McCULLOCH CORPORATION
SERVICE BULLETIN

1567

MODEL: Mini-Mac and Power Mac 6

SUBJECT: Sprocket and Drum Kit, P/N 90150, Bearing Installation Change.

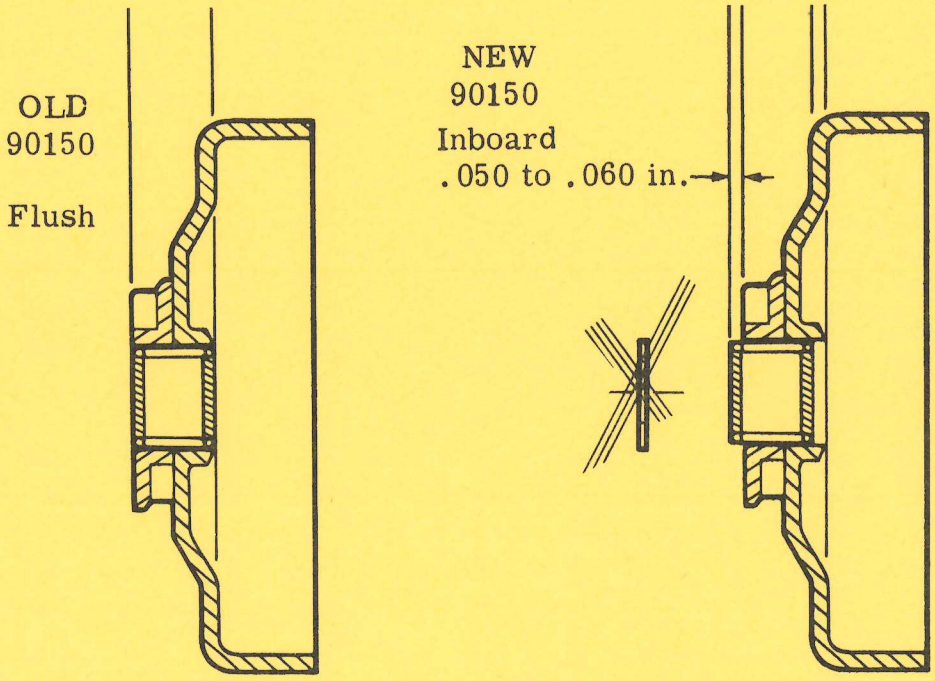
Sprocket and Drum Kit, P/N 90150, is now being assembled with the bearing pressed inboard to bring the centerline of the sprocket over the center of the bearing. This allows the bearing to protrude .050 to .060 inch (1.27 to 1.52 mm) from the face of the sprocket.

A sprocket washer is not required when the extended bearing kit is installed. Any washer previously used should be discarded.

NOTE: Approximately 300 kits have been shipped with instructions to install the sprocket washer. With installation of the extended bearing assembly however, these instructions no longer apply.
